Browns Ferry Nuclear Plant, Unit 1
Renewed Facility Operating License No. DPR-33
NRC Docket No. 50-259

Subject: **License Amendment Request under Exigent Circumstances for the Administrative Change to Remove the Notes on Technical Specification Figures 3.4.9-1 and 3.4.9-2**

**TENNESSEE VALLEY AUTHORITY
BROWNS FERRY NUCLEAR PLANT UNIT 1**

EVALUATION OF PROPOSED CHANGE

**Figure 3.4.9-1
Pressure/Temperature Limits for
Mechanical Heatup, Cooldown following Shutdown, and
Reactor Critical Operations**

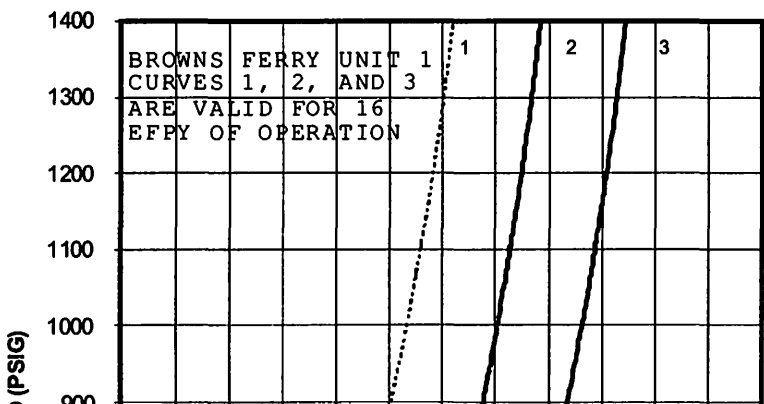
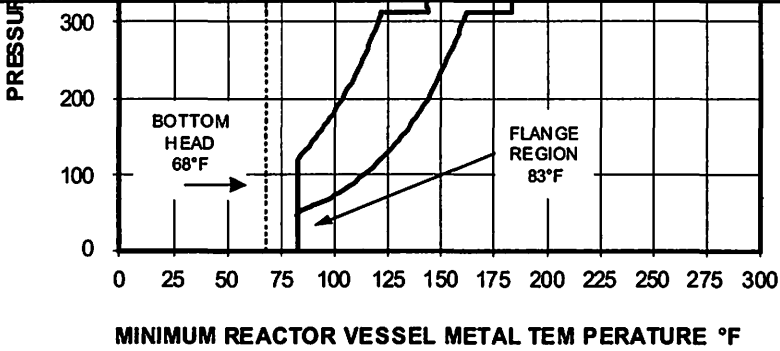
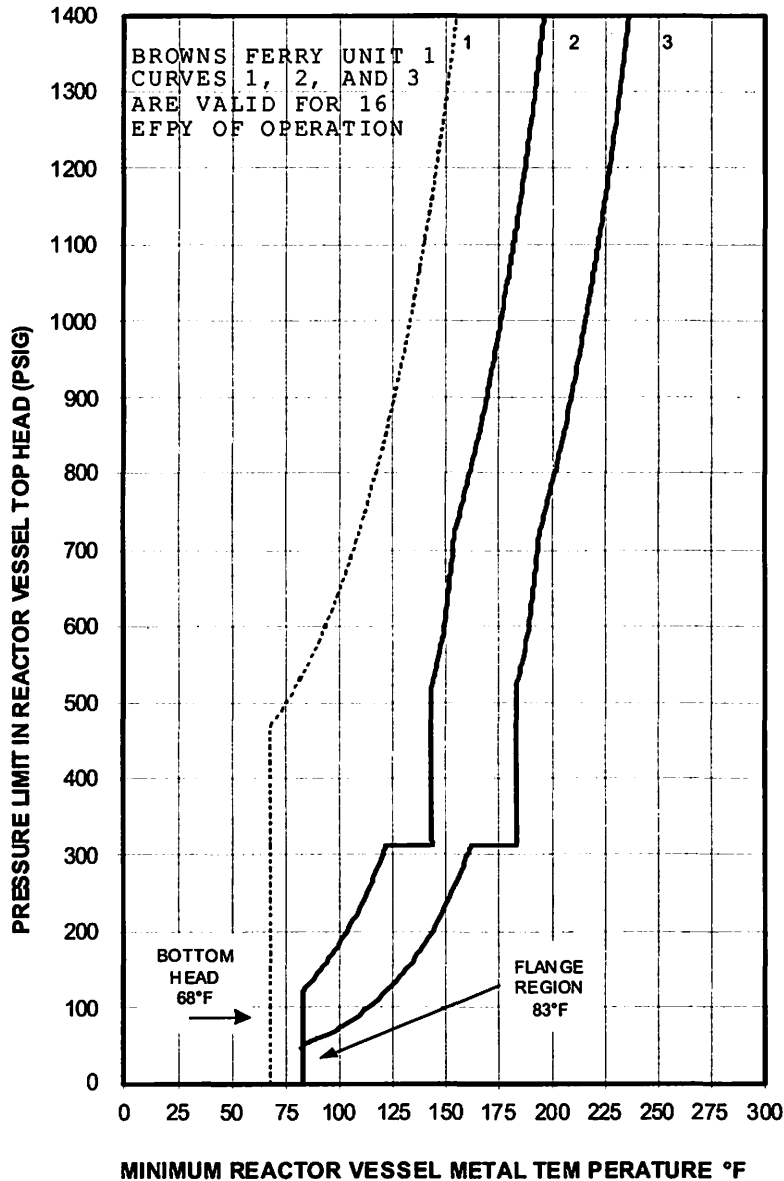
delete Note
from this
page

DO NOT USE THIS FIGURE

This curve applies to operations >12 EFPY.

For current operation, use previous curve, which is valid up to 12 EFPY.

**Figure 3.4.9-1
Pressure/Temperature Limits for
Mechanical Heatup, Cooldown following Shutdown, and
Reactor Critical Operations**

**Figure 3.4.9-2
Pressure/Temperature Limits for
Reactor In-Service Leak and Hydrostatic Testing**

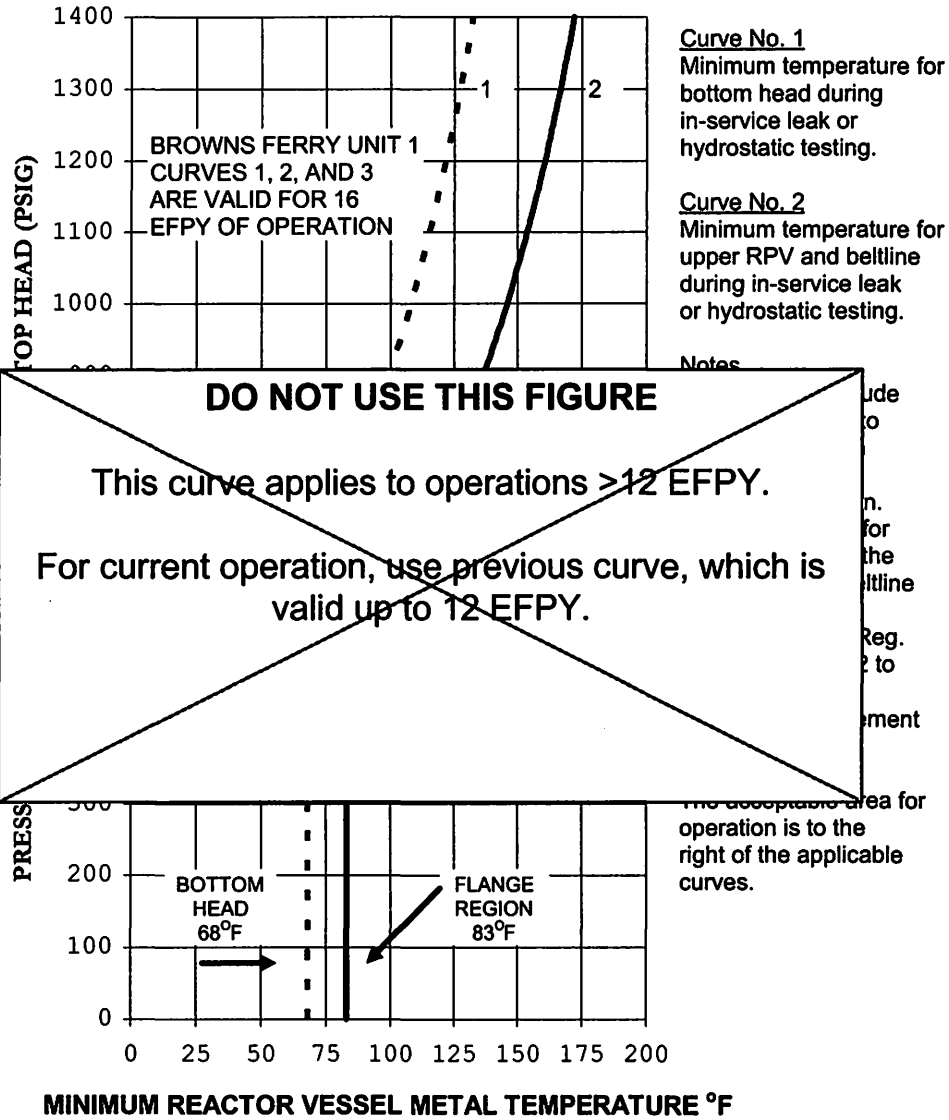
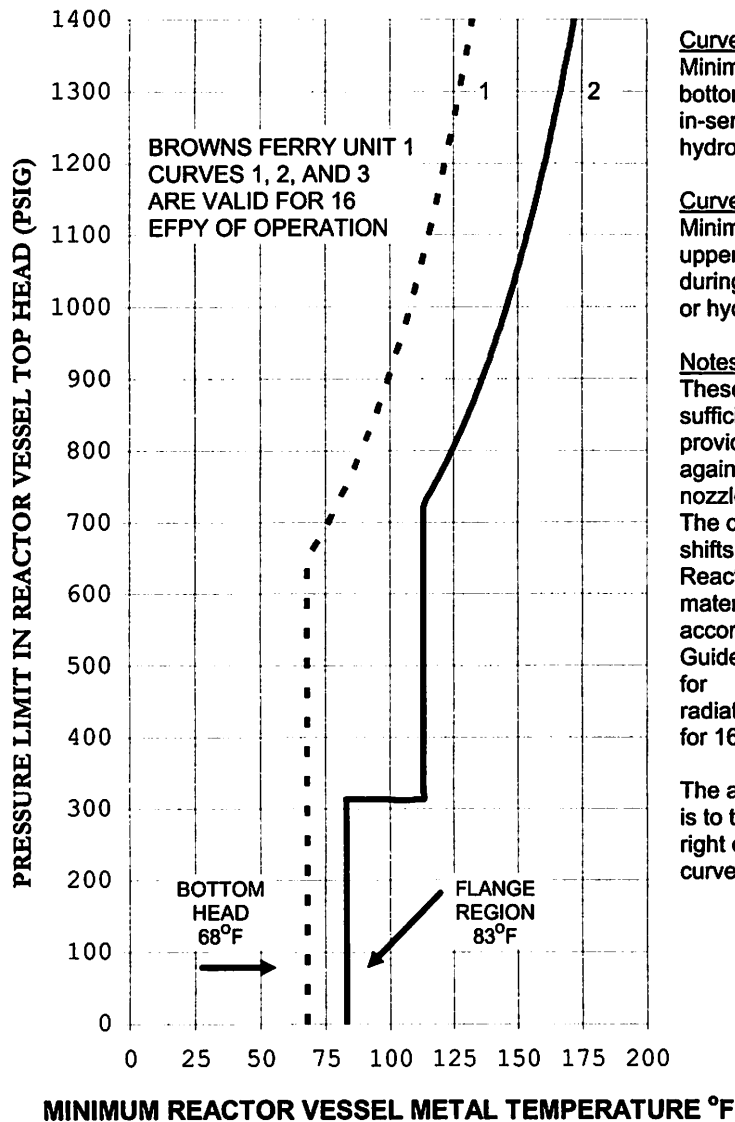
delete Note
from this
page

**Figure 3.4.9-2
Pressure/Temperature Limits for
Reactor In-Service Leak and Hydrostatic Testing**
